SUNNICA ENERGY FARM

8.82 FRA clarification document in light of proposed Scheme changes

Regulation Reference:	Regulation 5(2)(e)
Planning Inspectorate Scheme Reference	EN010106
Application Document Reference	EN010106/APP/8.82
Author	Sunnica Energy Farm Project Team

Version	Date	Status of Version
Rev 00	13 January 2023	Submitted at Deadline 5
Rev 01	30 January 2023	Submitted at Deadline 6
Rev 02	24 March 2023	Submitted at Deadline 10

**FIGURE 1
SUNNICA EAST
PARAMETER PLAN
FLOOD ZONES**

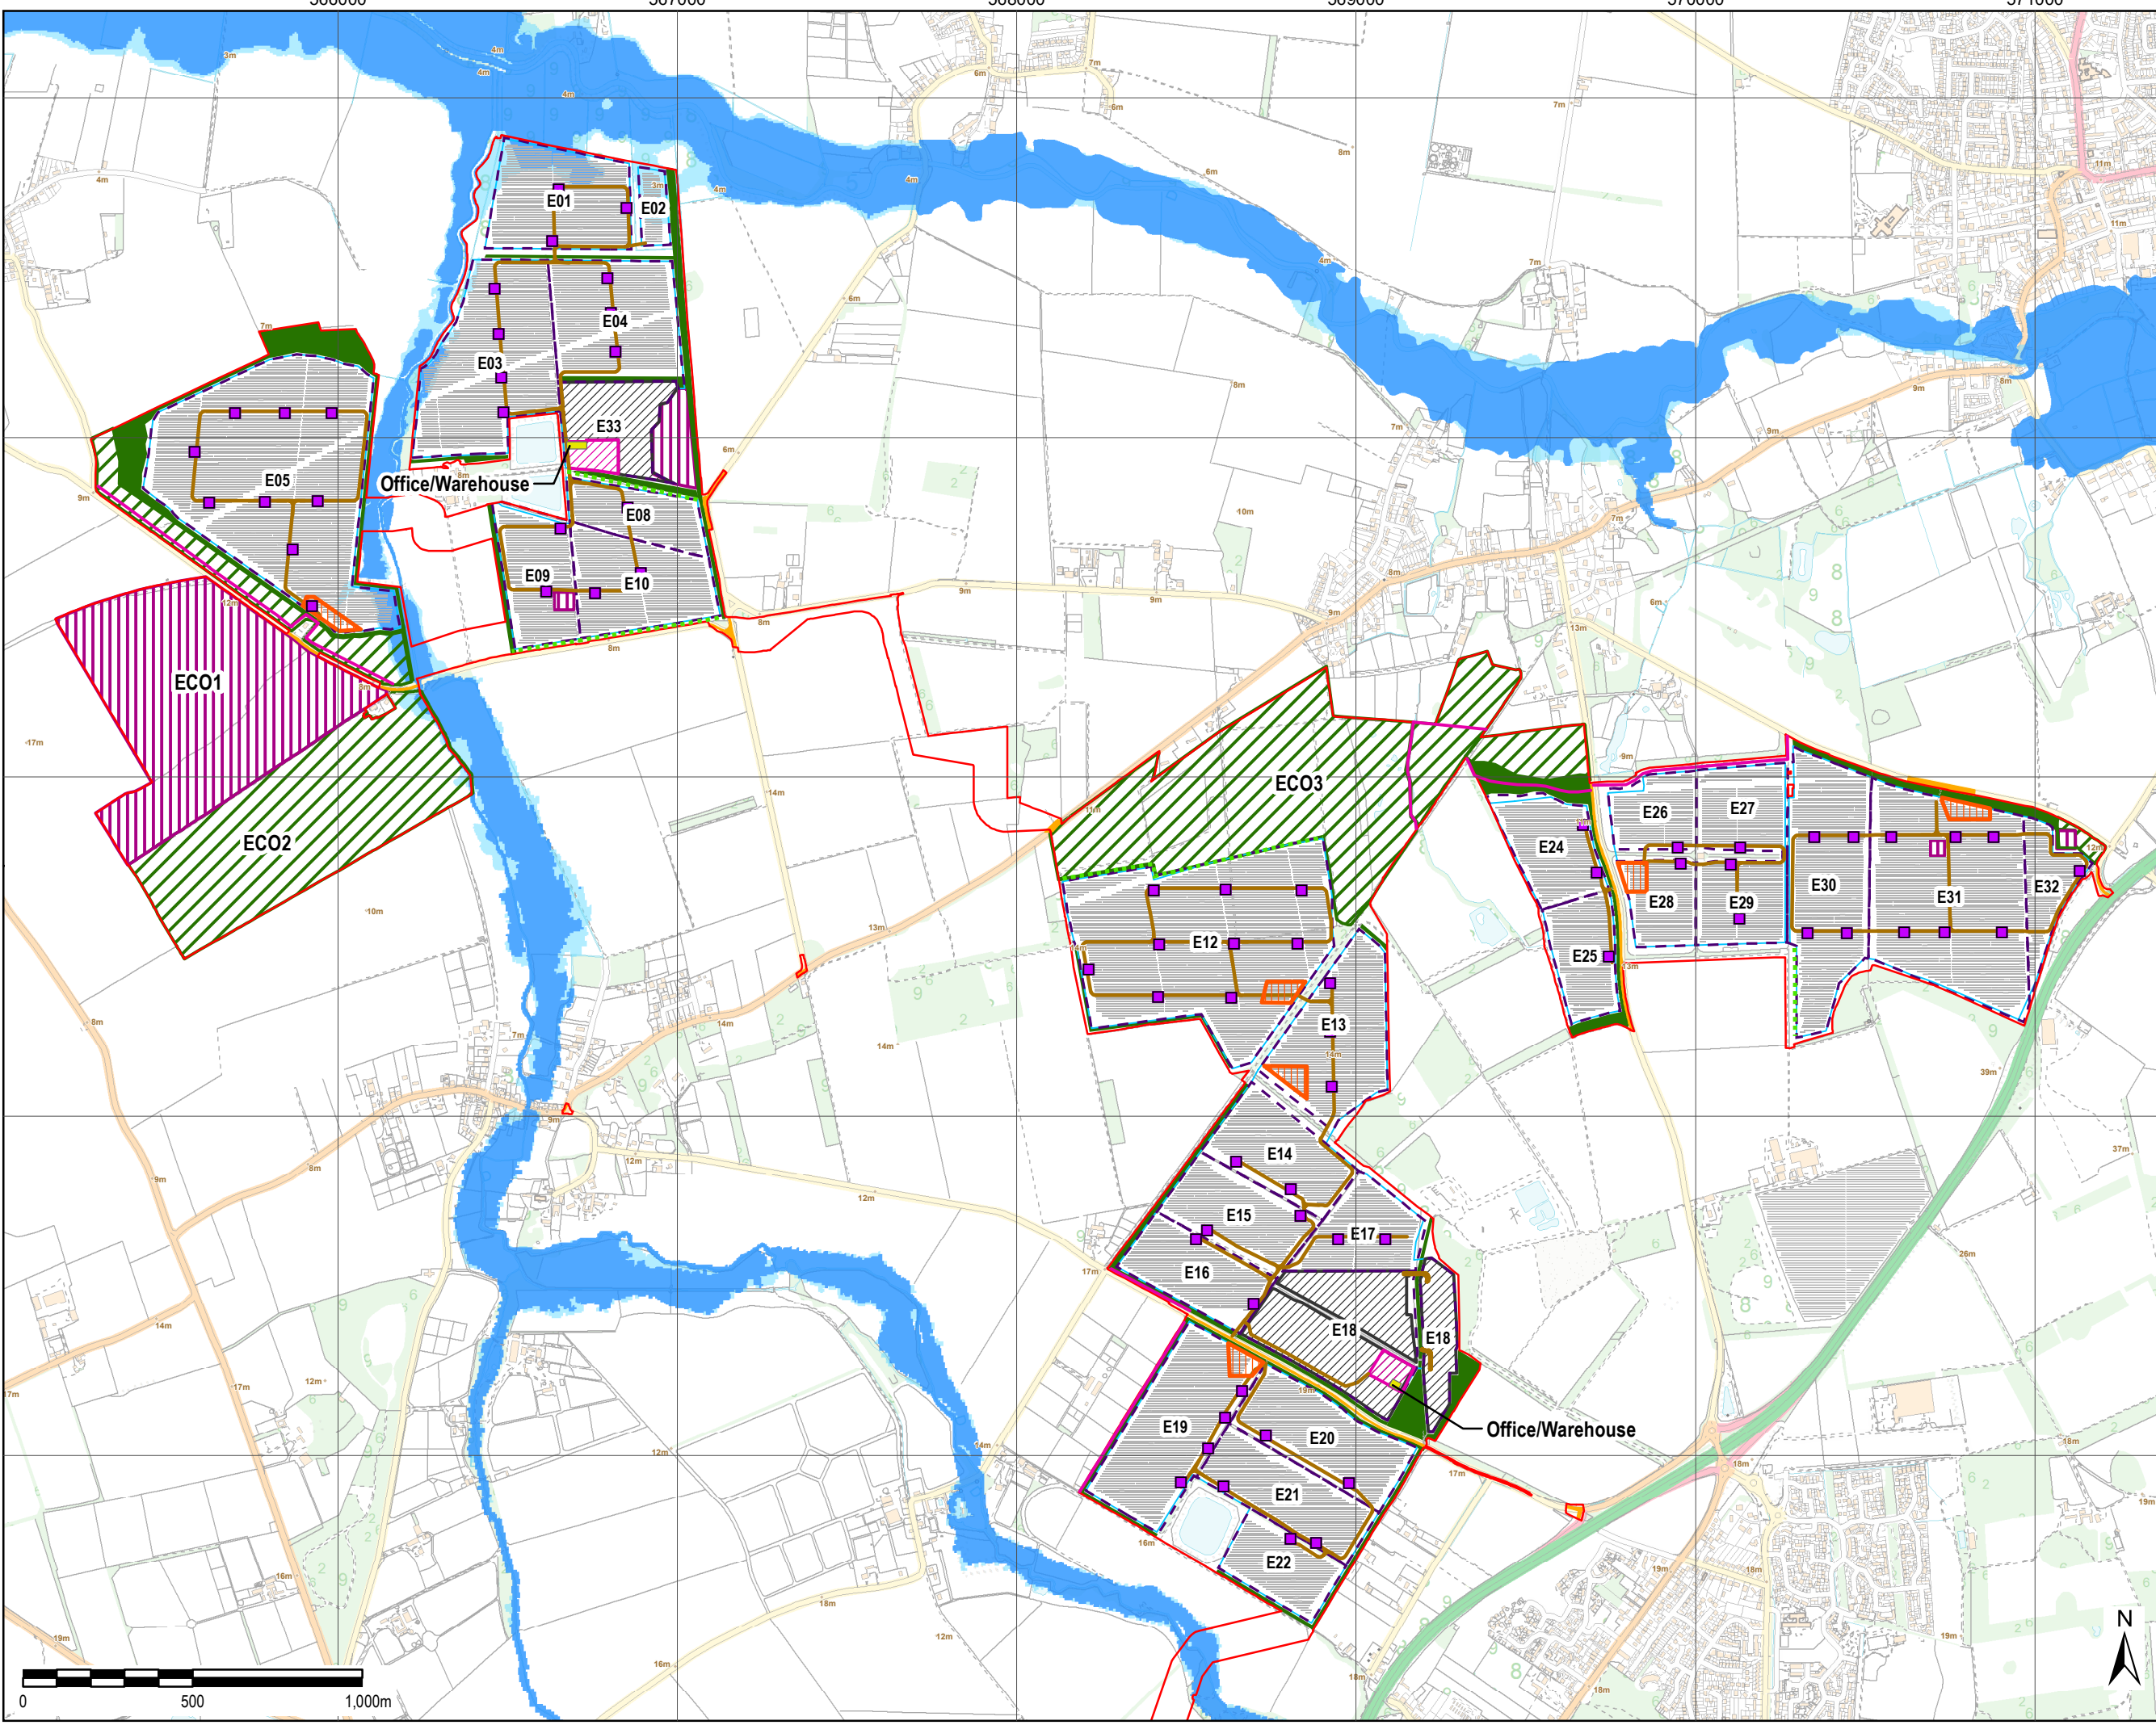
- Paragraph 1.7.1 (i) – which notes new substation at Burwell within Scheme proposals. The substation extension Option 2 is now removed from Burwell with no above ground built development proposed.

- Figure 14: Relating to Options 1 and 2 for the Burwell National Grid Substation Extension – There will now only a buried cable route into the existing substation, with no change to existing long term flood risk. Refer to revised Parameter Plans in Annex A for cable route to Burwell substation.

- 1.1.22 The subsequent removal of Option 2 removes the long term flood risk associated with the Burwell substation Option 2 Site. Therefore, there is no change to the existing long term flood risk within Burwell substation. This approach is consistent with the agreed approach to long term flood risk for the cable routes, where there is no permanent above ground installation proposed.

FIGURE 3
SUNNICA EAST
PARAMETER PLAN
RISK OF SURFACE WATER
FLOODING

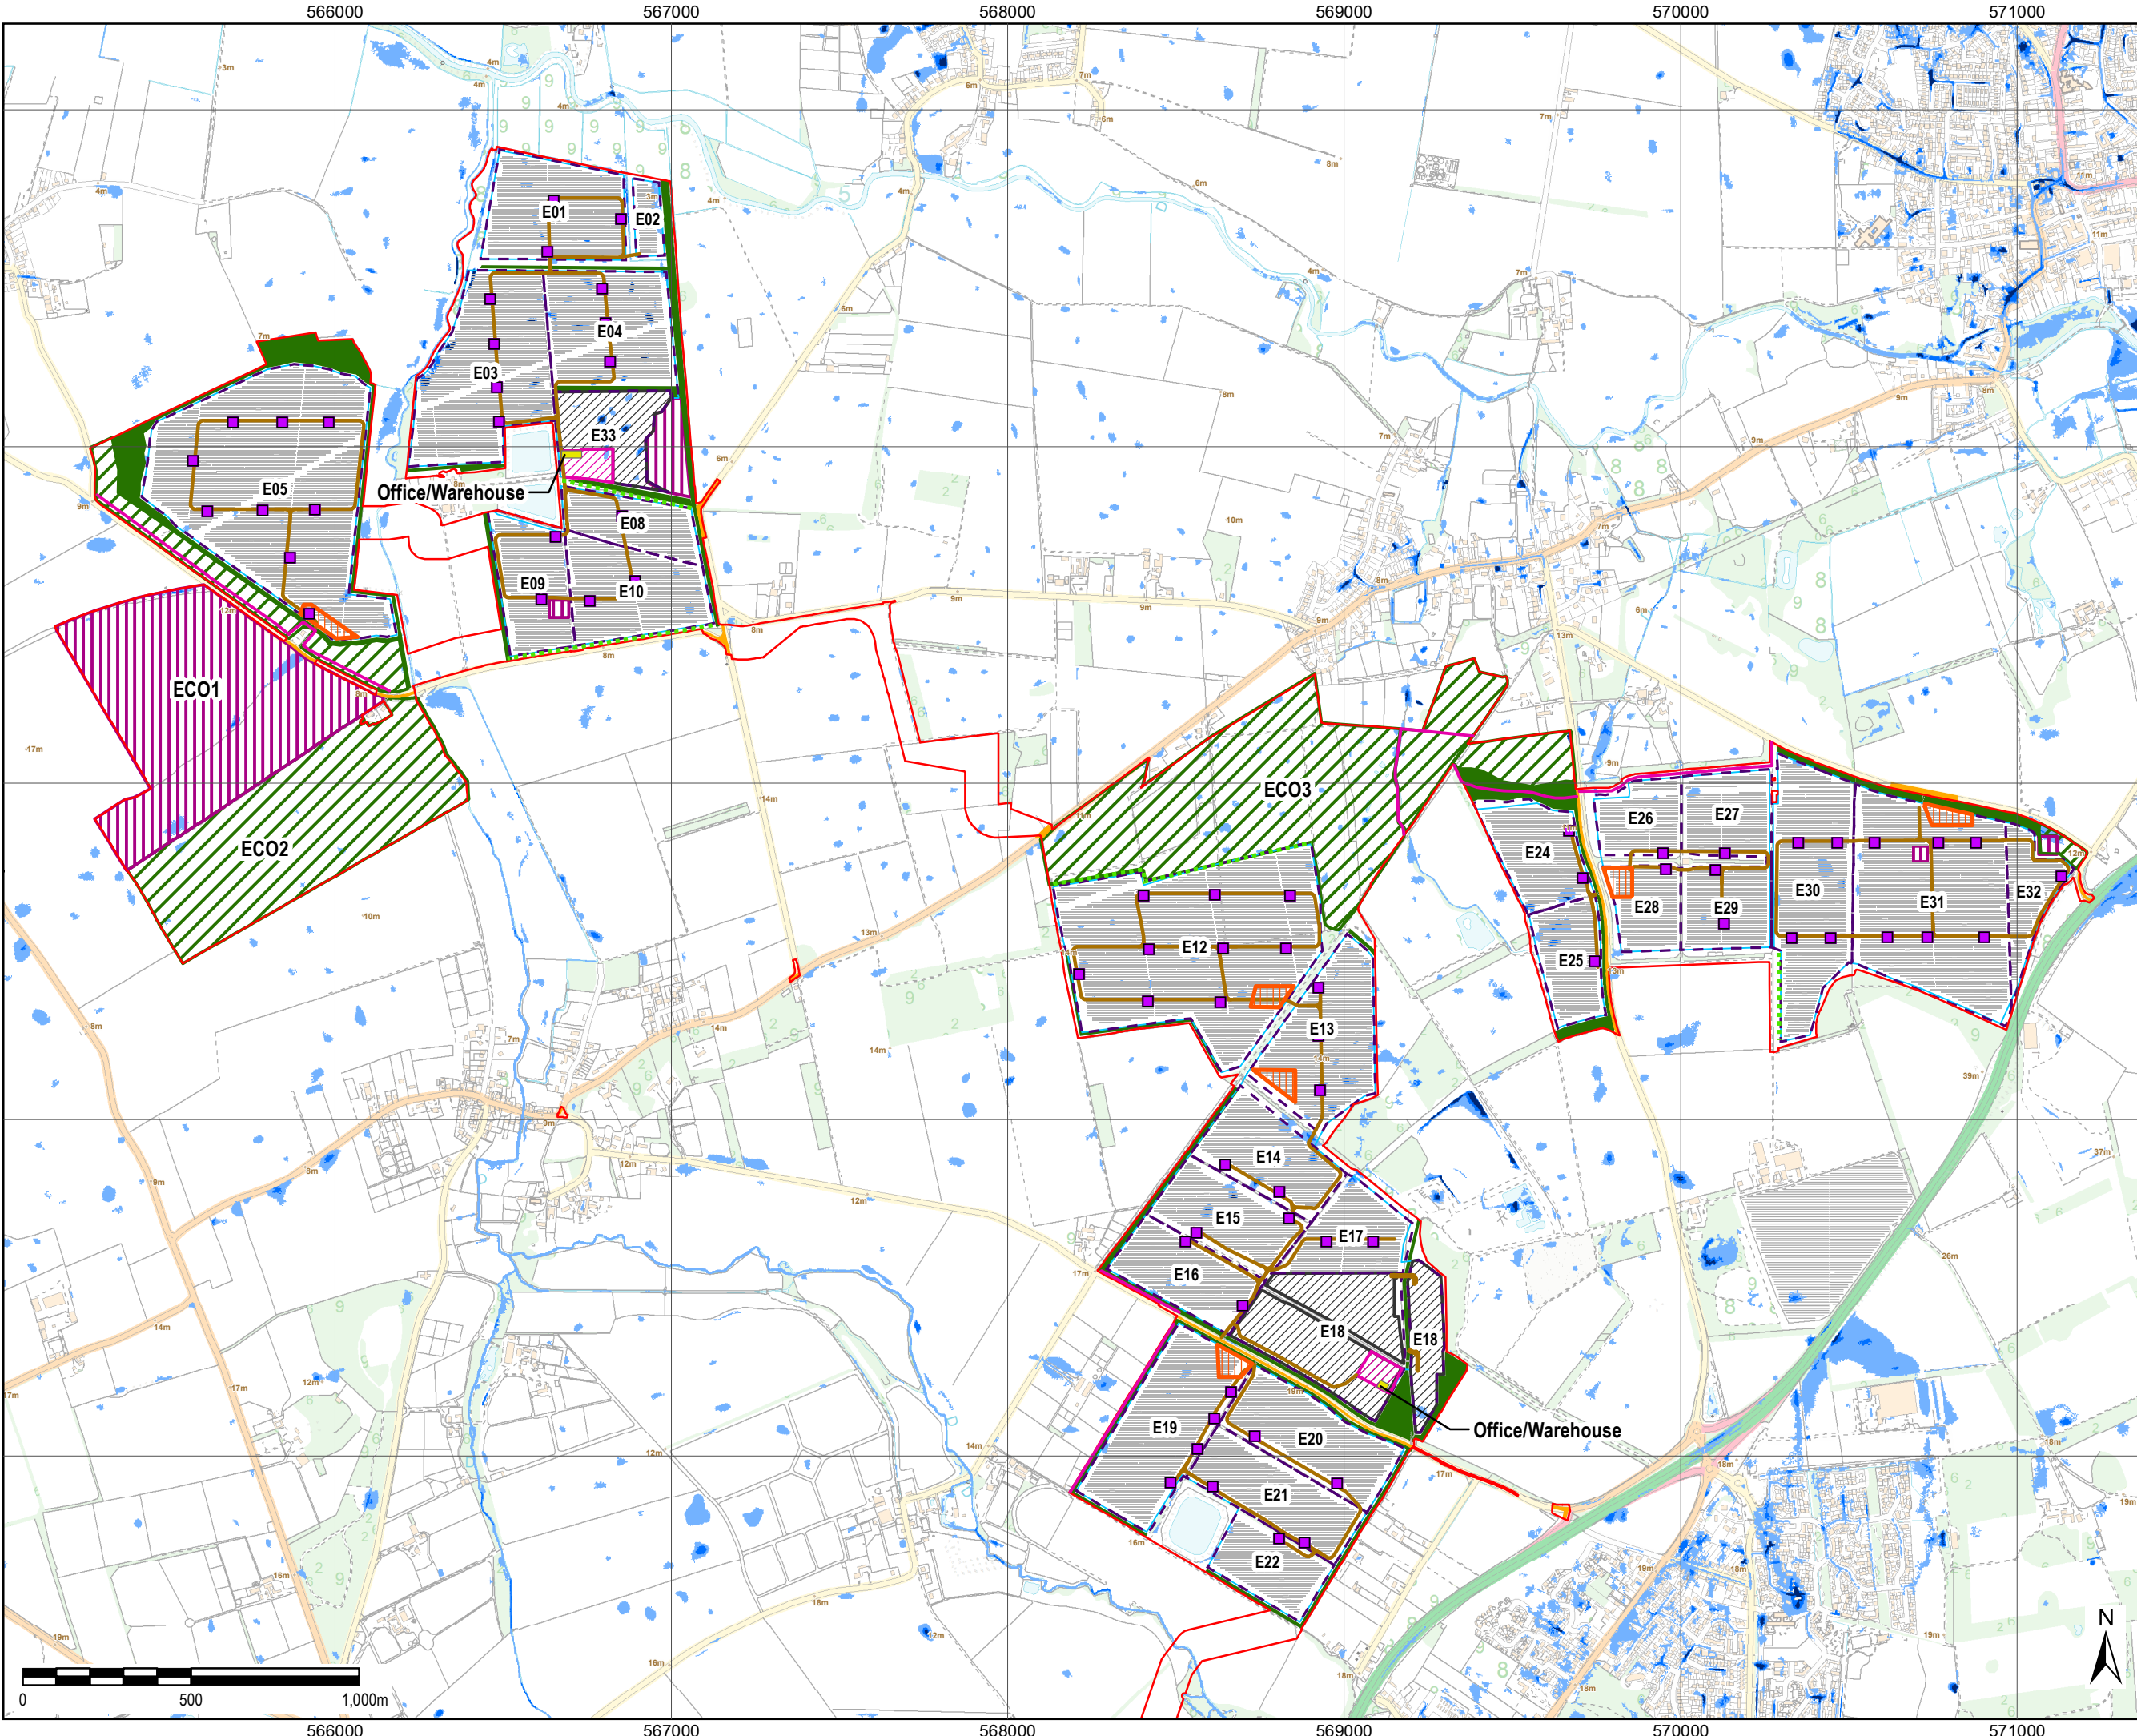
- 1.1.7 In addition, this document has been updated to respond to comments received at Deadline 5 from the Lead Local Flood Authorities (LLFA) to provide figures that indicate flood risk from surface water across the Order limits overlain on the indicative Parameter Plans. These figures are shown as Figure 3 and Figure 4 of Annex A. The figures, Figure 1 to 4 of Annex A, assist in putting in context the components of the Scheme with the areas at risk of flooding. It should be noted that the Scheme design shown on those plans is subject to further detailed design development within the scope of the parameters for which development
